Access Compliance Report Public Rights-of-Way (RR Crossings)

Intersection ID: 8157	Main Street: N_TRYON_ST	Location: N/A
ADA ID: 42560EC127E9	Overall Compliance: No	Severity Score: 0.0
Codes/Mitigation Info/Possible Solution		Field Measurements/Component Compliance

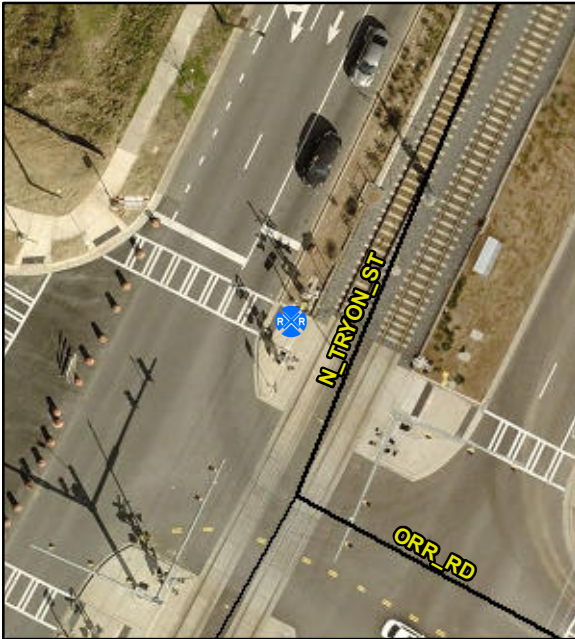
Compliance	Description	Data
Yes	DWS Provided?	Yes
Yes	DWS Contrast?	Yes
Yes	DWS Width (in)	Yes
Yes	DWS Length (in)	24.0
Yes	DWS Offset (in)	153.0
No	Pedestrian Gate?	No
N/A	DWS Outside Gate?	Yes
N/A	Rail Type?	LightRail
No	Flangeway Gap (in)	28.0
Yes	Sidewalk Width (in)	119.0

Provide Pedestrian Gate. Remove & Replace Walking Surface Adjacent to Rail.

R302.7.4, R305.2.5
